# PLAN COMMISSION STAFF REPORT

**Agenda Item:** PC Docket No. 23-013

**Application:** **Zoning Amendment – Planned Unit Development Amendment**

**Summary:** Matt Kimmel/Centennial Village LLC, is requesting approval of an amendment to the Centennial Village Planned Unit Development, revisions to the CV Design Standards and Site Plan to include revisions to the size, location, and shape of Buildings "I" and "M."

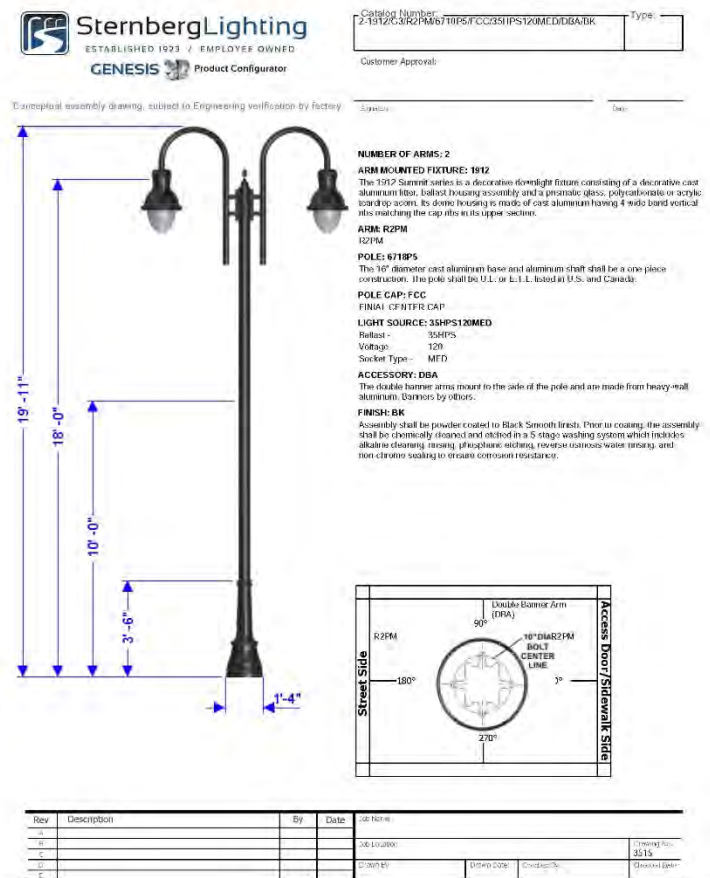
Staff understands that the petitioner has additional amendments to the Conceptual Plan that will be presented at a later date. Those changes are already being shown in the updated Conceptual Plan that the petitioner has submitted with this application. For clarity and to reduce confusion, staff would like to request that a revised Conceptual Plan that only illustrates the changes being approved as part of this petition be included in the revised Centennial Village PUD Design Standards document. Alternatively, the hotel site be more clearly indicated by using a hatch over the area and labeling that it is excluded.

- 1. Revisions to the proposed building and land use language for consistency purposes within the document (change the proposed use of the term “commercial” to “retail”).*
- 2. Revisions to the proposed Conceptual Plan to only show the changes requested to buildings “I”, “M”, and the associated parking lot.*
- 3. Revise any references to Building F to be a “Retail – Multi Tenant” use rather than “Retail – Single Tenant” to reflect how the structure is actually being used.*
